## Request for Proposals (RFP) Amendment

Request for Proposals  
Highland Estates Homeowners Association Road Repair Project  
Issued: April 8, 2026

### Amendment #1

PROJ. NO.	3747	OVERALL SITE PLAN
DWG. BY	RM2	HIGHLAND ESTATES ROAD REPAIR
APPR. BY		COL. PAC. ECONOMIC DEV. DISTRICT
FILE	D-3747-C-1-C	DATE 09/16/2025

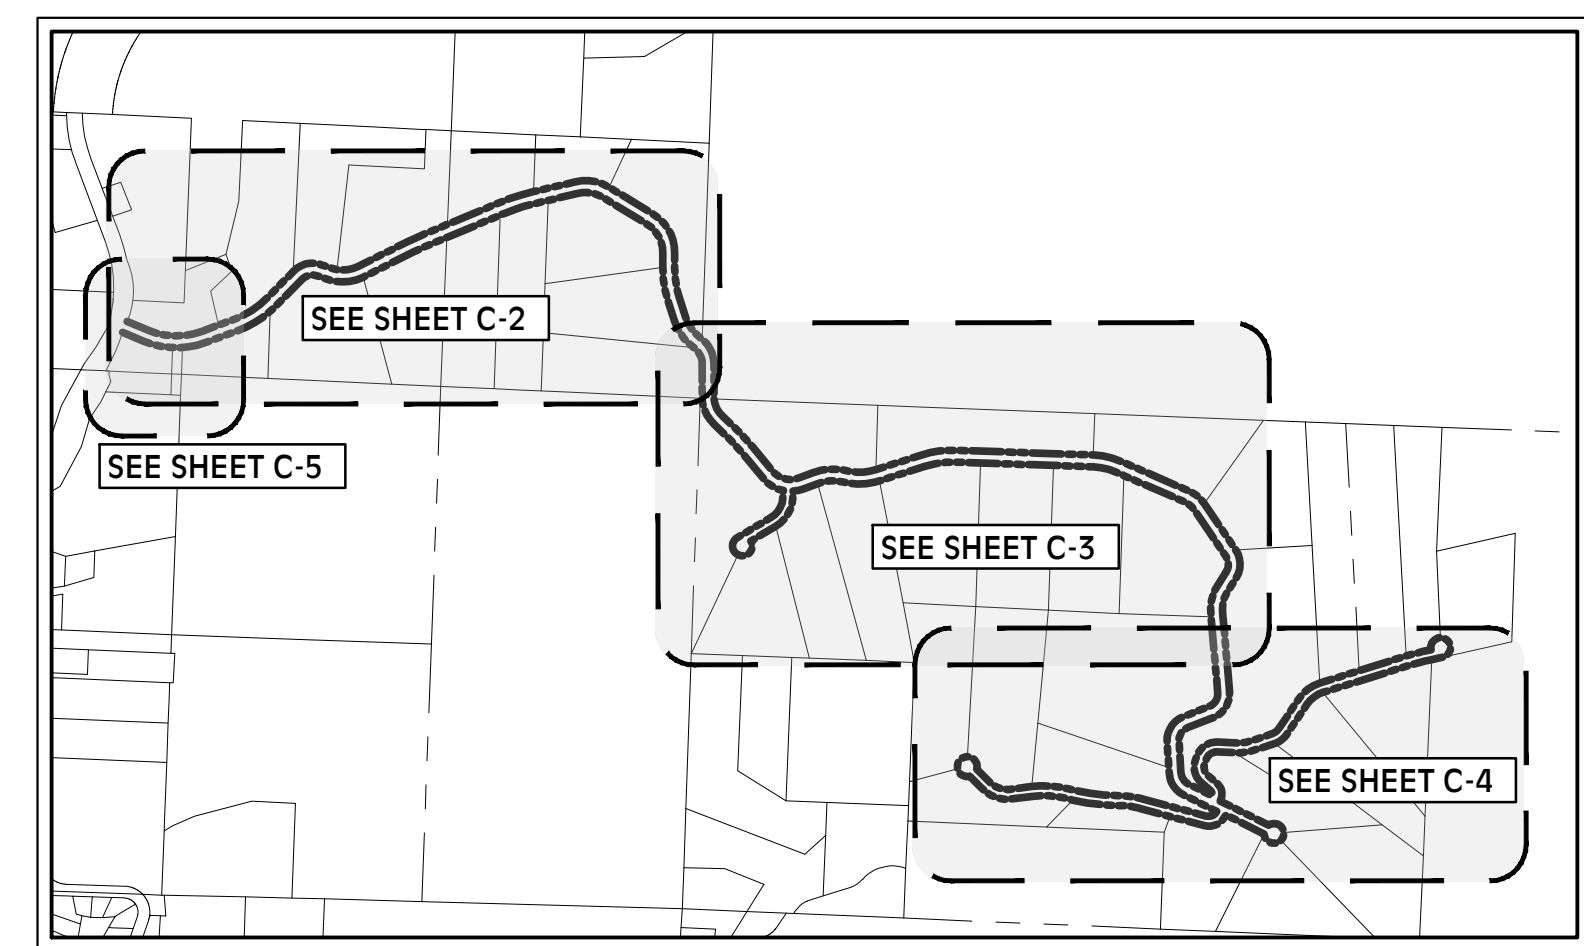
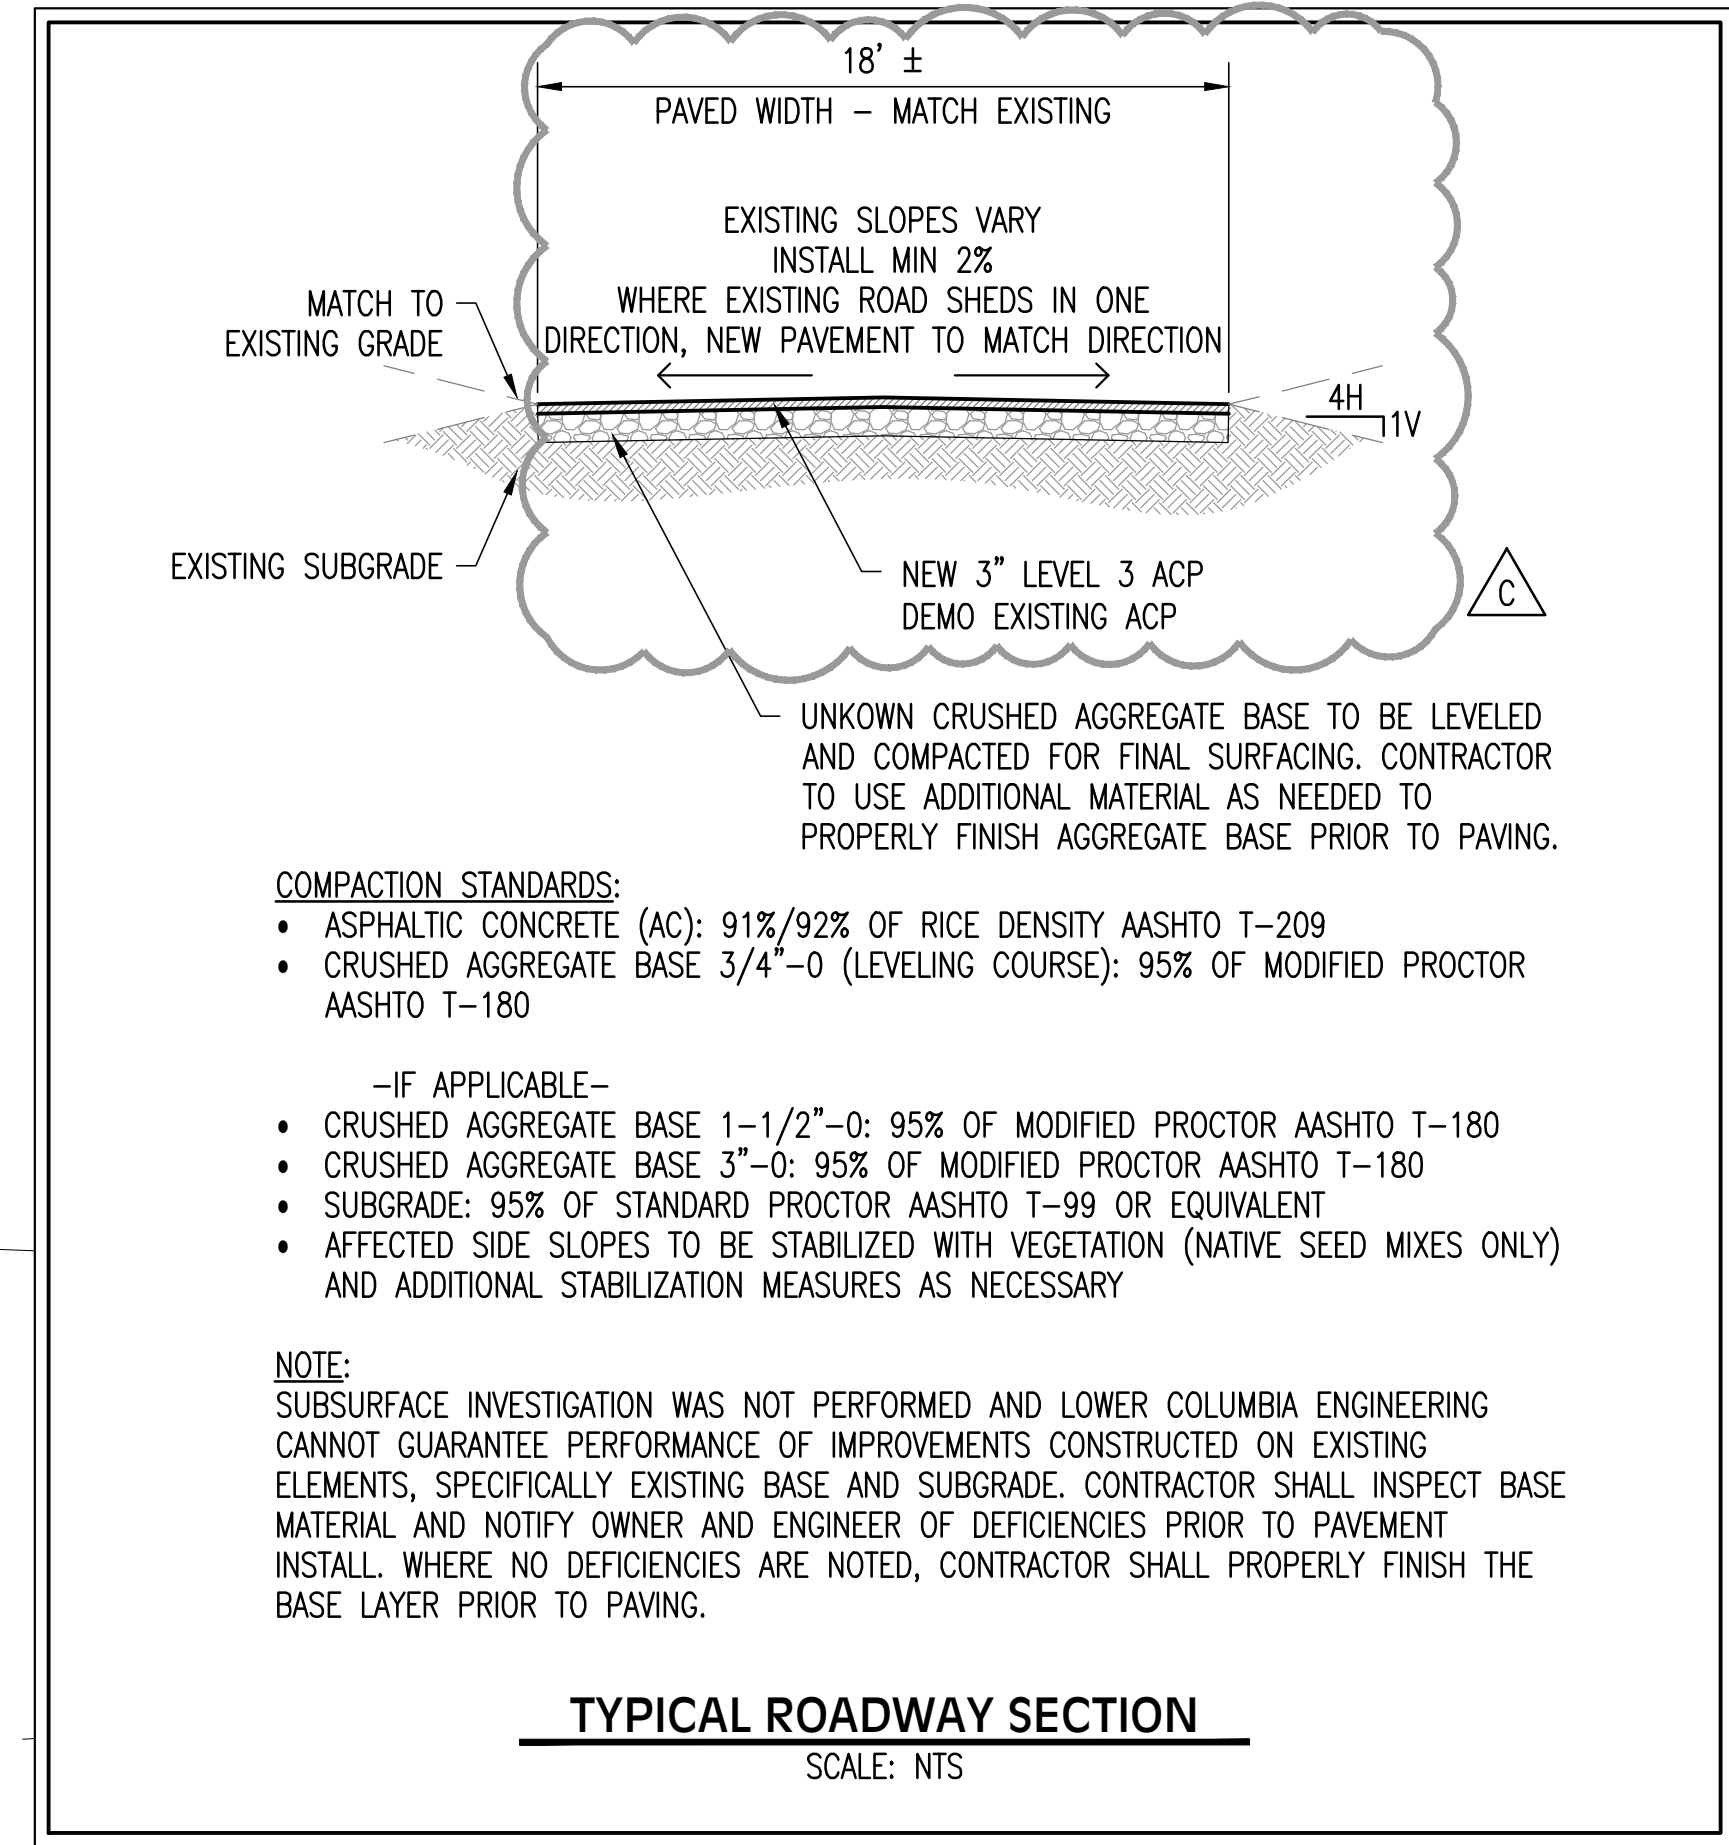
1. The extent of Erosion and Sediment Control perimeter measures.

**ANSWER:** ESC Plans have been developed to illustrate anticipated extents of BMP measures that might be needed. Perimeter measures may not be needed along the entire length of the roadway improvements but there is a chance that they will be needed. Contractors are responsible for ensuring the project area is adequately stabilized and is not transporting sediment.

**SHEET C-1**

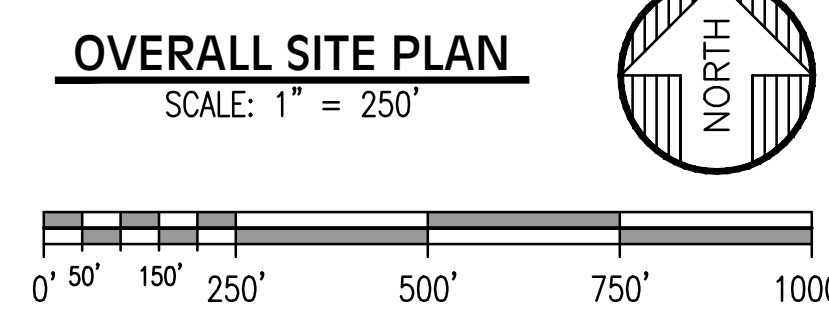
##### Addition to Typical Roadway Section on C-1:

If the existing road slopes in one direction (as opposed to crowning in both directions as shown in the section), then that should be maintained.
